**WINDHAM TECHNICAL HIGH SCHOOL
SOFTBALL FIELD ADDITION
WILLIMANTIC, CONNECTICUT
PROJECT: BI- RT - 856**

BID OPENING	1:00 P.M.	April 24, 2012
ADDENDUM NUMBER 1	DATE OF ADDENDUM	March 30, 2012

UNDERDRAIN CLEANOUT DETAIL

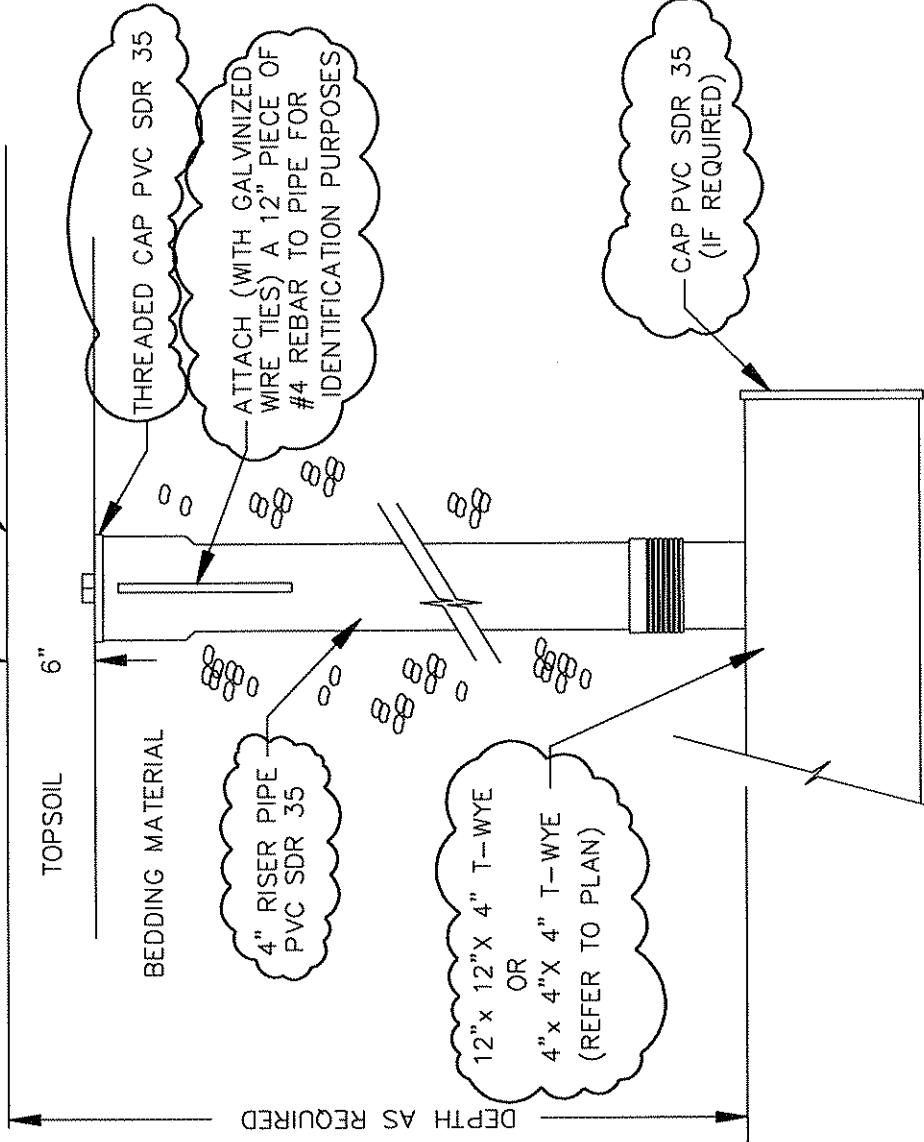
On Drawing C.06 SITE DETAILS, **DELETE** Detail 6 UNDERDRAIN CLEANOUT DETAIL and **SUBSTITUTE** SK-01herein attached.

18-05011 REVISIONS TO DETAIL

DRAWING PREPARED TO
SUPPLEMENT PLAN SHEET C.06
